August 29, 2008

ADDENDUM NO. 2
FOR THE
WILLOWS SENIOR CENTER FIRE DAMAGE REPAIR

Notice is hereby given that the following revisions, clarification, additions and/or deletions are hereby made of, and incorporated into plans and specifications for the **WILLOWS SENIOR CENTER FIRE DAMAGE REPAIR.**

SHEET NO.
AD-2.1

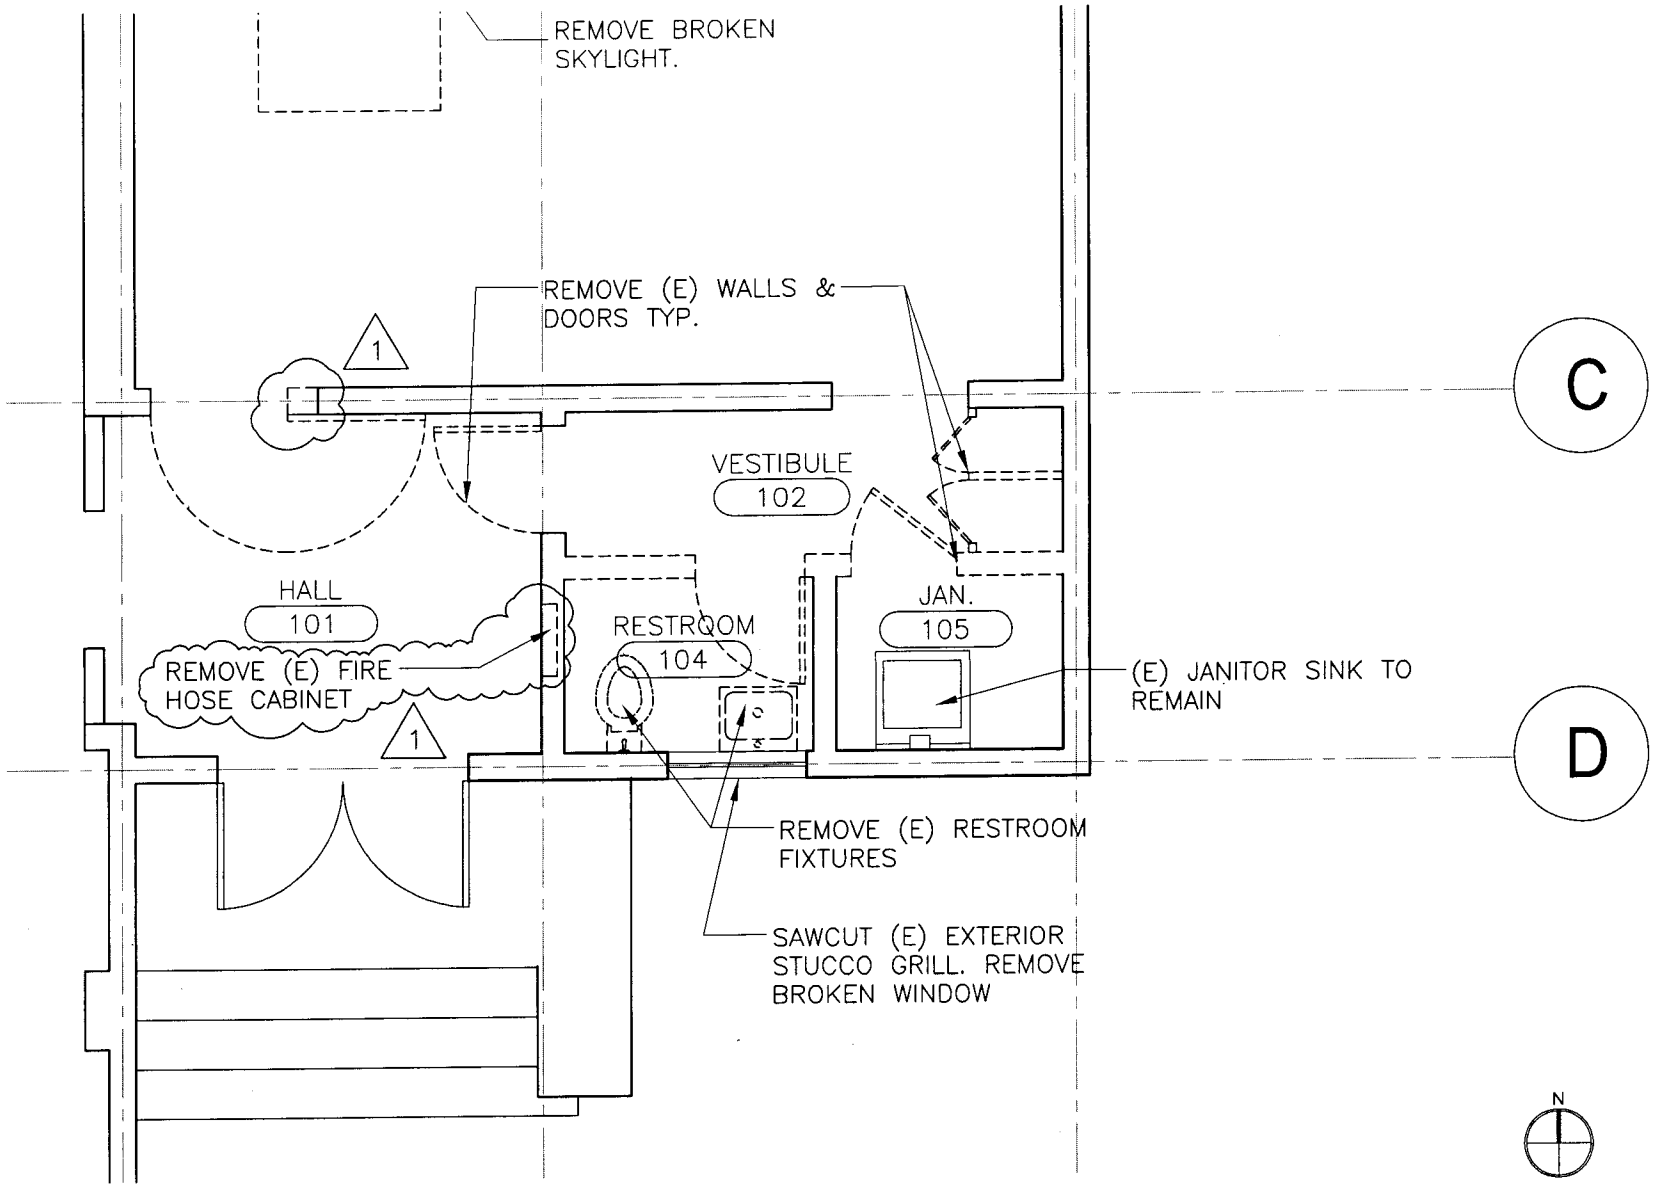
Question #3:
Drawing A-2: Note 10 states to remove only the damaged wall insulation. Note 8 on page A-3 calls for new insulation. Will all the existing ceiling and wall insulation be removed and replaced or only damaged insulation?
Answer #3:
Note 10 is deleted. See drawing clarifications #1 below.

1. **Clarification** on sheet A-2 below:
    - **Revise** Note 8 – "DEMOLITION TO INCLUDE REMOVAL OF ALL FIXTURES, WALL INSULATION, EQUIPMENT, WALL, CEILING AND FLOOR FINISHES, GYP. BD. & MISC. ITEMS THROUGHOUT THE AREA OF WORK."
    - **Delete** Note 10
    - **Add** new demolition scope to include removal of existing fire hose cabinet and wall demo at Hall 101. See attached drawing **AD-2.1**
    - **Add** new demolition scope at Food Storage 110 to include bigger openings. See attached drawing **AD-2.2**

SHEET NO.
AD-2.2

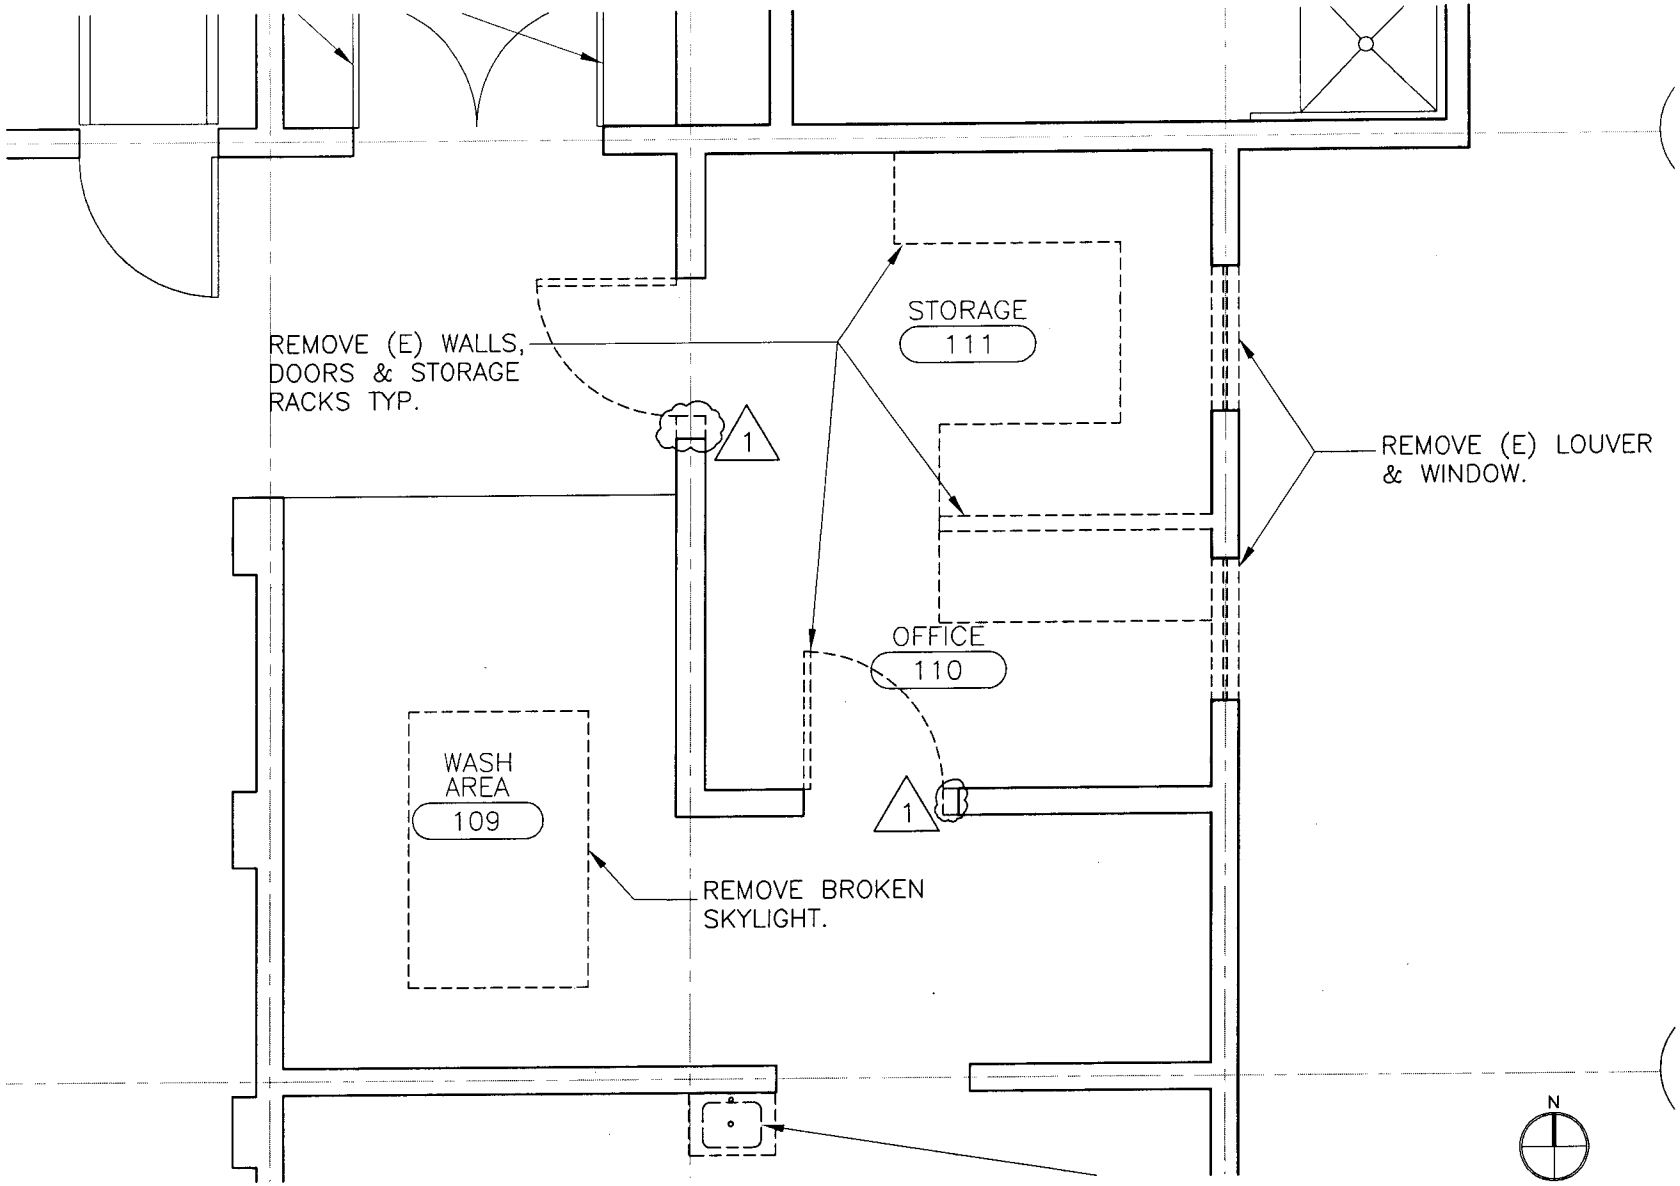
Question #6:
E-1 appears to be too large to go through the existing doors. This will be a maintenance issue please increase the size of one door or order a smaller oven?
Answer #6:
Change door 110 opening width. See drawing clarifications #2 below.

SHEET NO.
AD-2.3

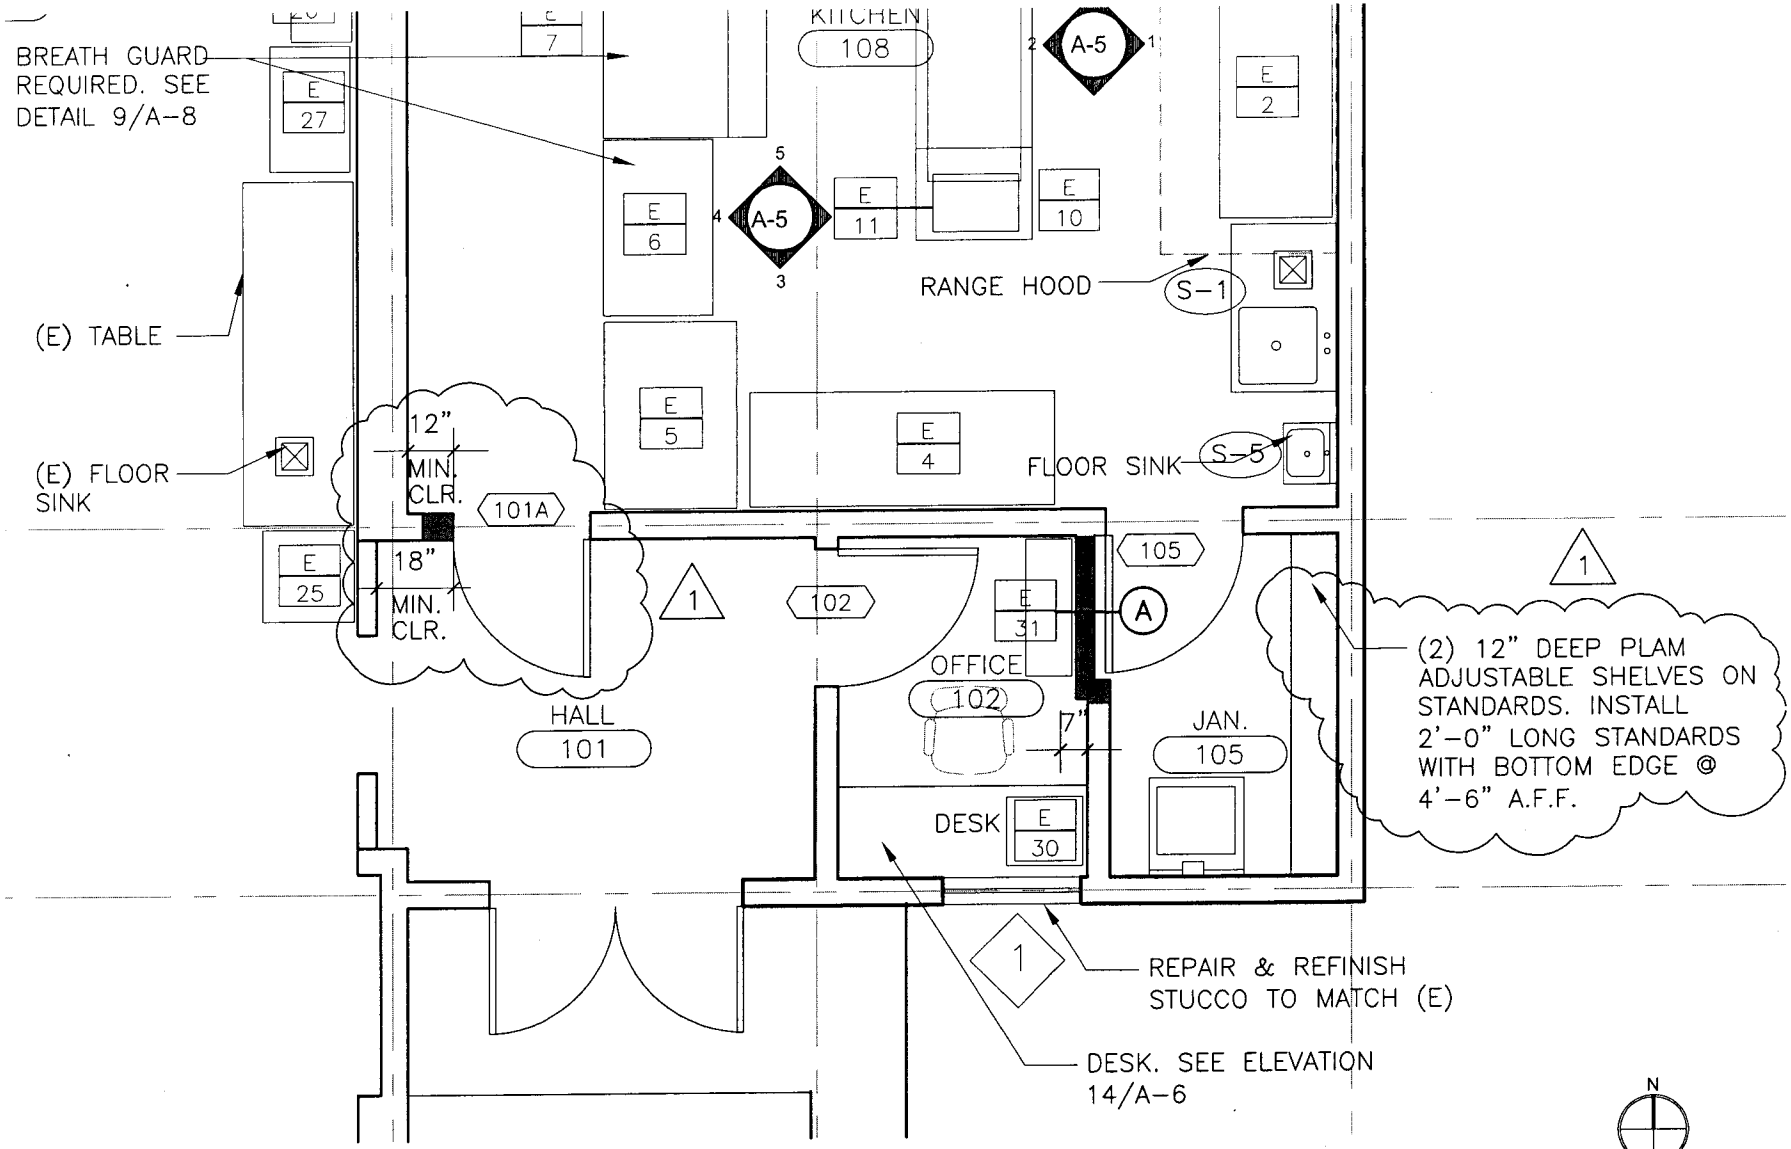
Question #7:
Drawing A-2: Door 101A is an exit door that swings inside the building. This does not meet ADA requirements as drawn. There needs to be an eighteen inch minimum on the pull side to meet the code.
Answer #7:
Change drawing to reverse door swing. See drawing clarification #2 below.

Question #8:
Room 105 on column line 1 between c & D has an unidentified line that appears to possibly be a shelf. Please clarify?
Answer #8:
Revised drawing indicates shelf location. See drawing clarifications #2 below.

2. **Clarification** on sheet A-3 below:
    - **Change** door swing of exit door 101A. See attached drawing **AD-2.3**
    - **Add** note to indicate plastic laminate adjustable shelves in Janitors' 105. See attached drawing **AD-2.3**
    - **Change** door 110 to 3 feet 6 inch door and clear opening from Food storage 110 to Wash Area 109 to be 34 inches. See attached drawing **AD-2.4**
    - **Revise** Note 8 – "PROVIDE ACOUSTICAL INSULATION AT ALL NEW AND EXISTING INTERIOR AND EXTERIOR WALLS IN THE AREA OF WORK."

SHEET NO.
AD-2.4

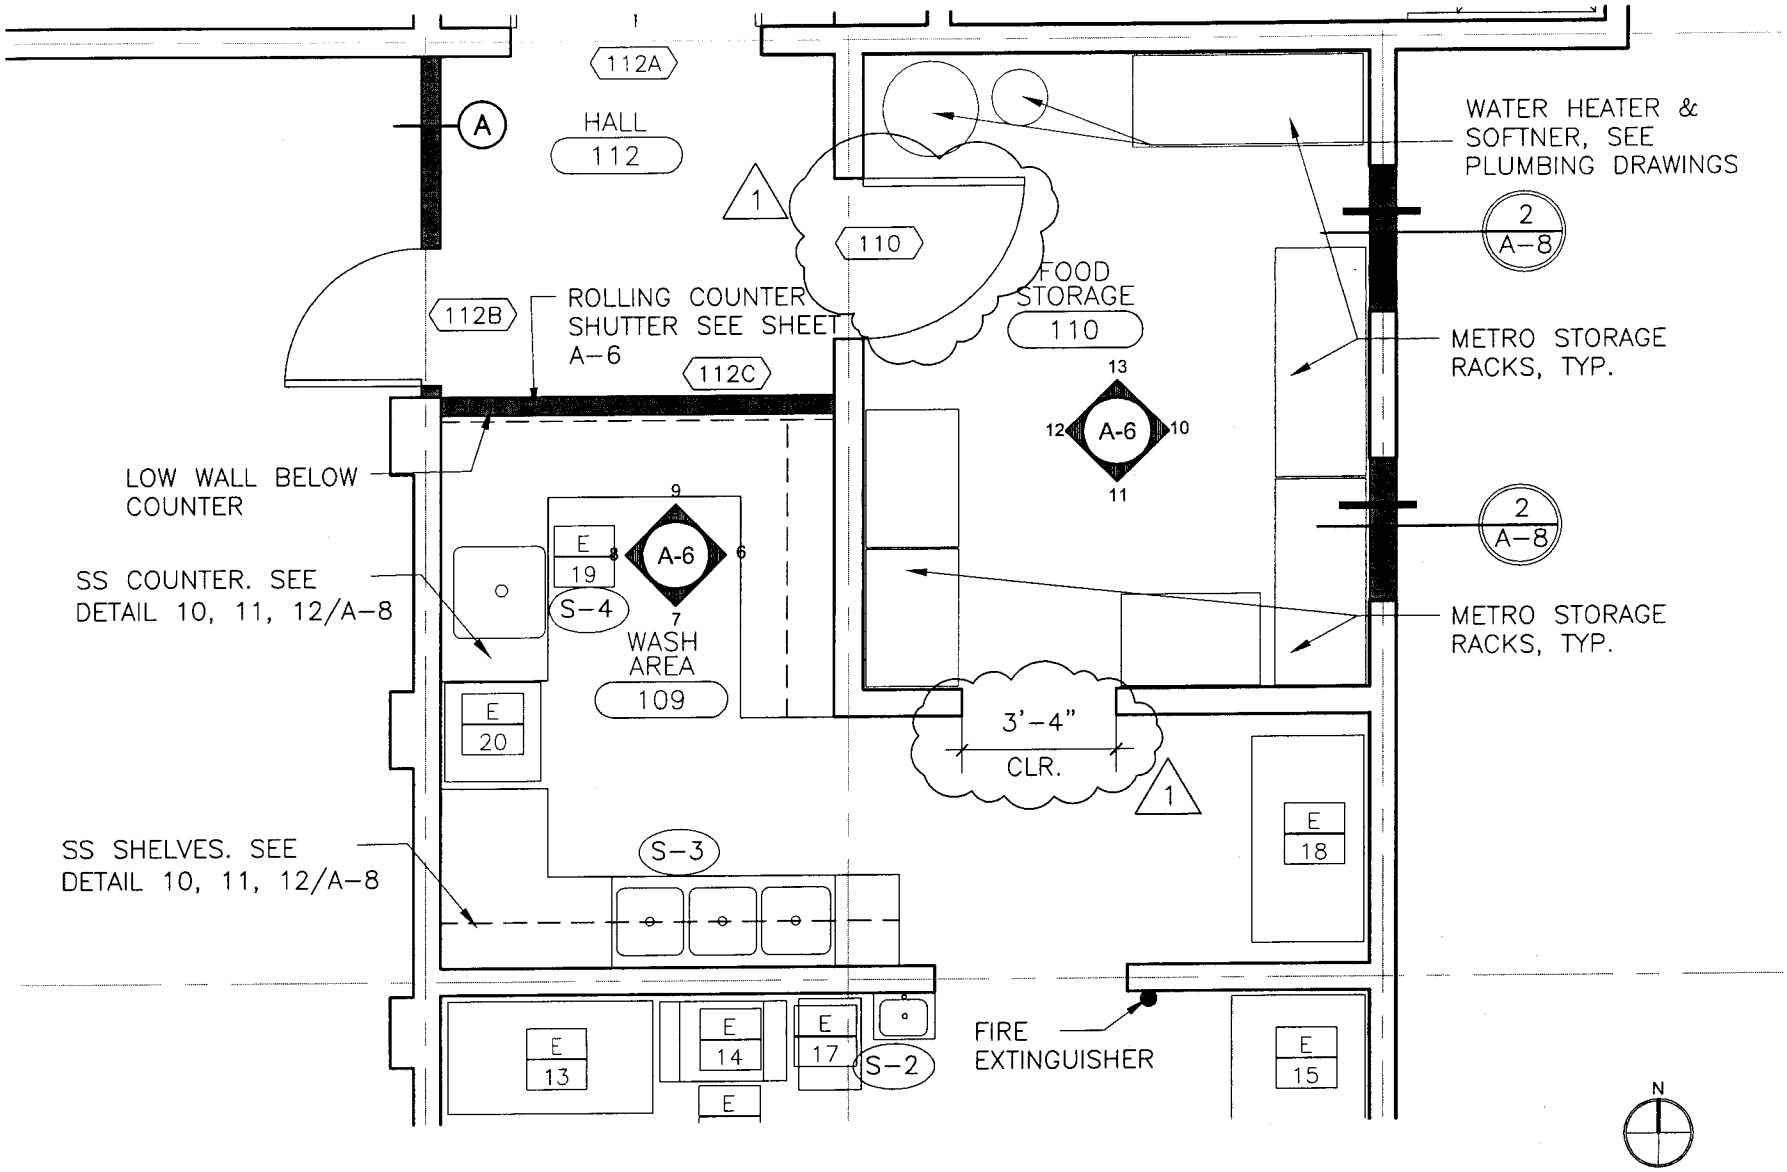
Question #21:
Specification 07213 2.2B
Sound batt insulation calls for acoustical glass fiber insulation meeting a flame & smoke of 10 sound batt is 25 & 50. Thermo fiber meets the 10 rating but at twice the cost. Please clarify which product is to be used.
Answer #21:
Note 8 on sheet A-3 is updated. See drawing clarification #2 below.

SHEET NO.
AD-2.5

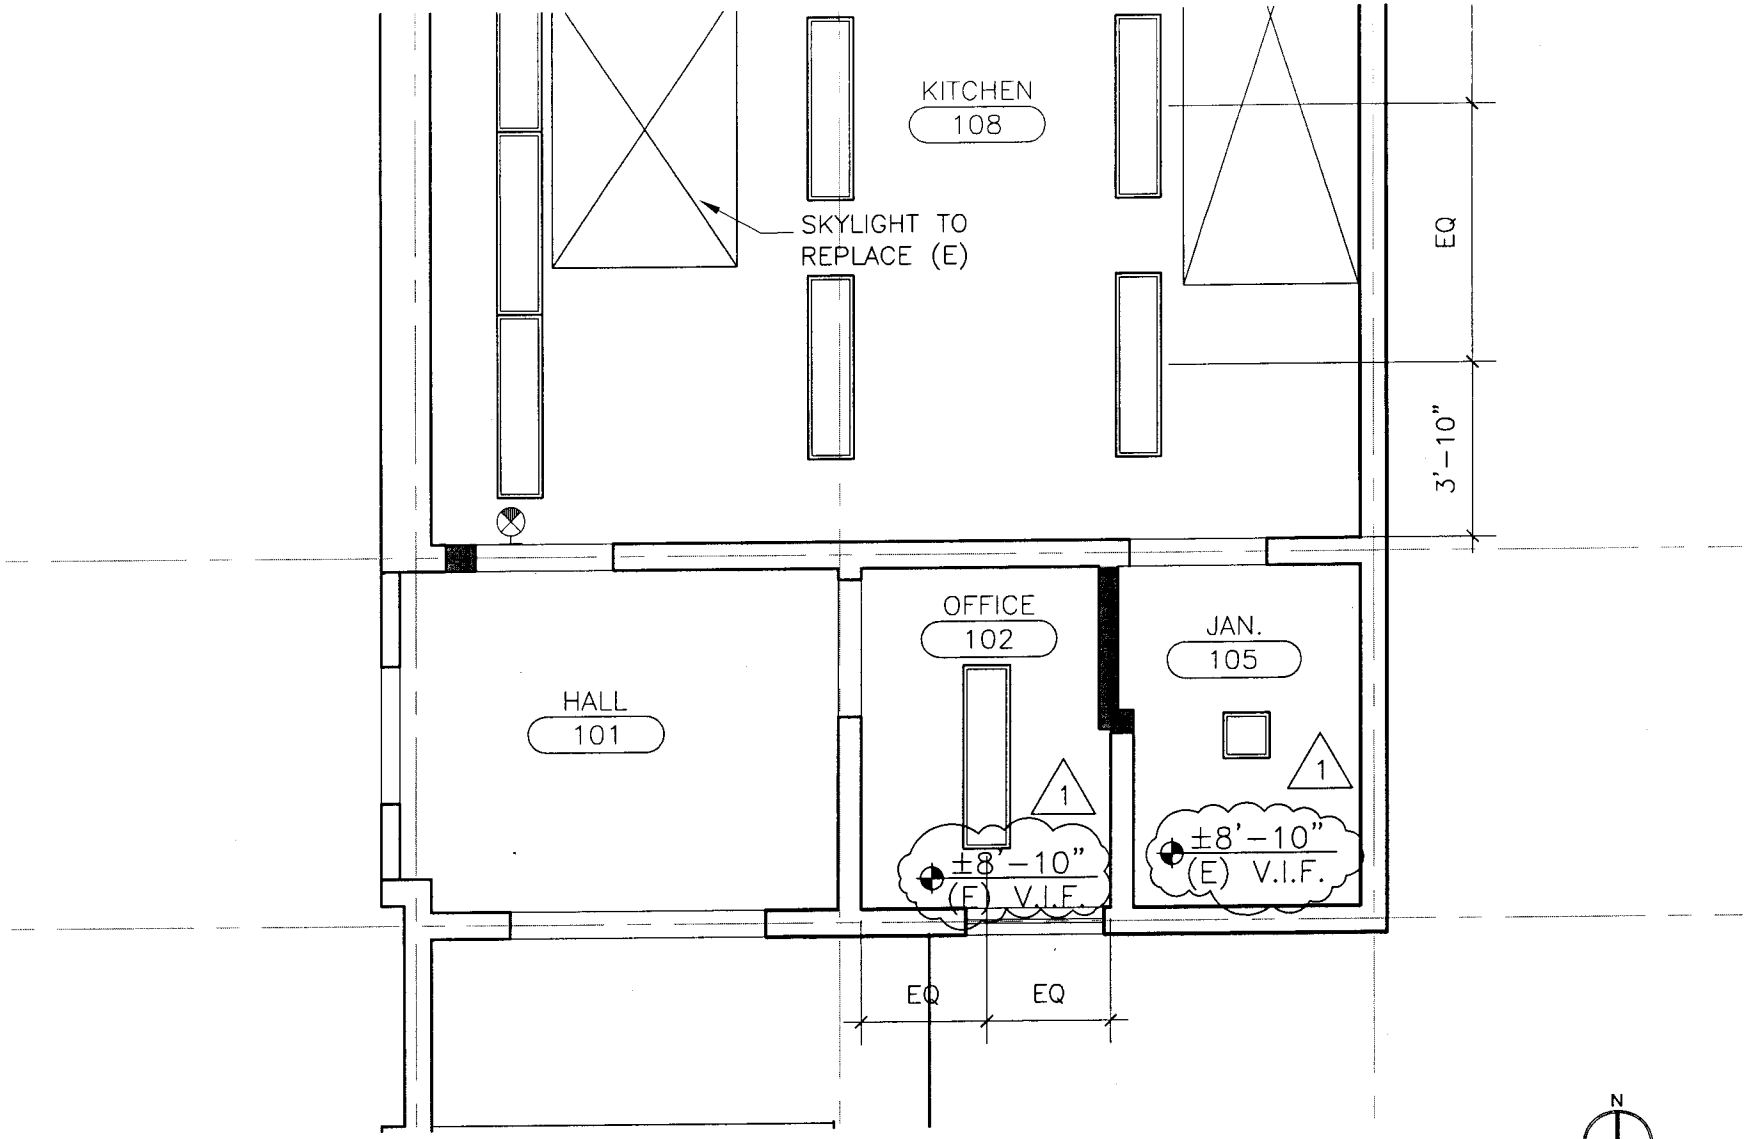
Question #9:
Drawing A-4: Room 110, 112, 102 and 105 show existing ceiling to be 8 foot high, the current framing is approximately 8 foot 10 inches?
Answer #9:
Revised drawings indicate Room 110, 112, 102 & 105 ceiling height to be ±8 feet 10 inches, to be verified on field. See drawing clarification #3 below.

3. **Clarification** on sheet A-4 below:
   - **Change** new ceiling heights to match existing in room 102 & 105. See attached drawing **AD-2.5**
   - **Change** new ceiling heights to match existing in rooms 110 & 112. See attached drawing **AD-2.6**
   - **Change** light at Hall 112 to 1x4. See attached drawing **AD-2.6**
   - **Change** location of mechanical access panel. See attached drawing **AD-2.6**
